Placemaking Report

I-90 Allston Interchange Improvement Project

October 2016

Prepared for the City of Boston
Boston Planning & Development Agency

Provide a Third North/South Arterial Street (Standard #18)

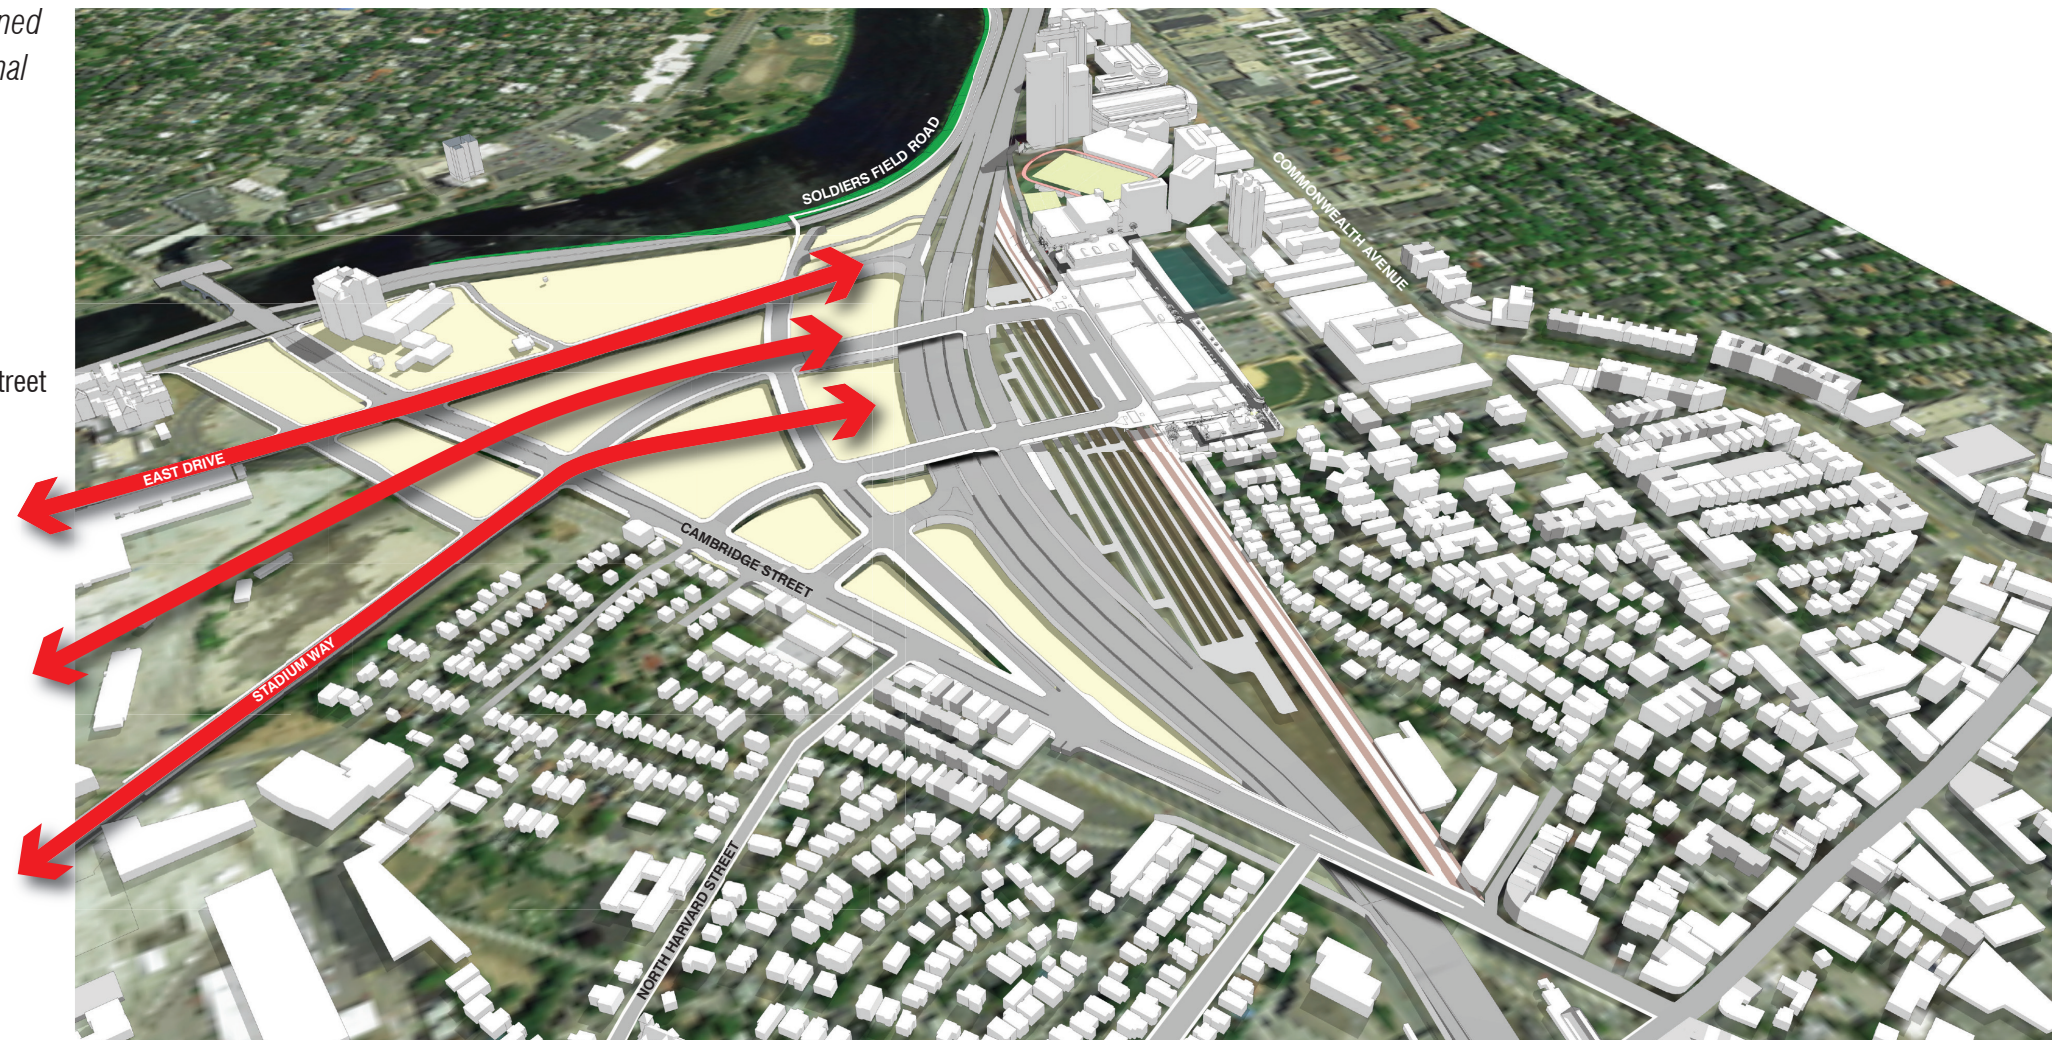
Provide three north-south arterial streets across Beacon Park Rail Yard aligned with three north-south streets now being planned for the Harvard Institutional Master Plan (IMP) area.

- Analyze and plan for future alignment and operations of these streets to meet multiple goals.
- Reduce need for traffic to use Cambridge Street, thereby enabling a narrower street and smaller intersections.

- Create a more dispersed traffic pattern that reduces concentration and congestion by providing more choices and more intersections.
- Provide enhanced capacity for dedicated or prioritized transit lanes.

- Create well-proportioned and smaller blocks that will promote well-scaled development patterns and additional frontage opportunities.
- Provide at least one through connection to North Harvard Street

An additional north/south street - augmenting the two streets envisioned in Alternative 3K-4 - will allow for a broader distribution of traffic and more choices for drivers and transit routes in the future. The three streets can align directly with new streets being planned by Harvard north of the study area, reducing the need for motorists to make turns onto Cambridge Street. The smaller dimensions and proportions of the blocks that will be created by adding a third street are conducive to a pedestrian environment and a diversity of potential building types and uses.

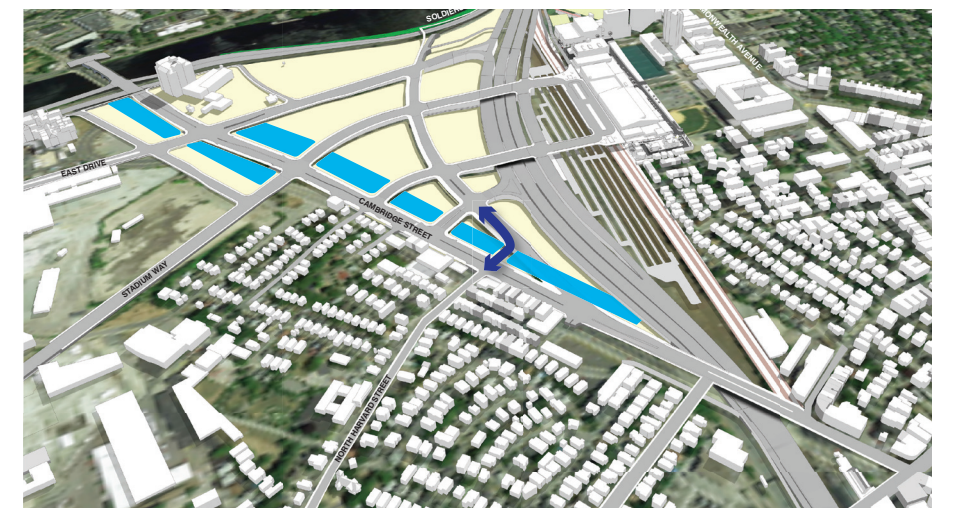
A more direct intersection between Cambridge Street South and North Harvard Street at Cambridge Street would limit neighborhood impacts and reduce unnecessary turning movements, congestion, and street and intersection widths along Cambridge Street.

- The current intersection concepts may result in congestion leading back into the neighborhood that simplified intersections might relieve.
- Other standards in this report may help limit traffic from using the North Harvard Street connection by adding more and better access to the highway ramp areas, which may reduce the demand along North Harvard Street.
- The traffic implications of the flows and intersection alignment at North Harvard should be evaluated as part of the ongoing modeling and studies in order to determine if a direct connection would result in significantly increased traffic impacts on North Harvard Street.

Simpler intersections would provide a better opportunity for desirable development on both sides of Cambridge Street.
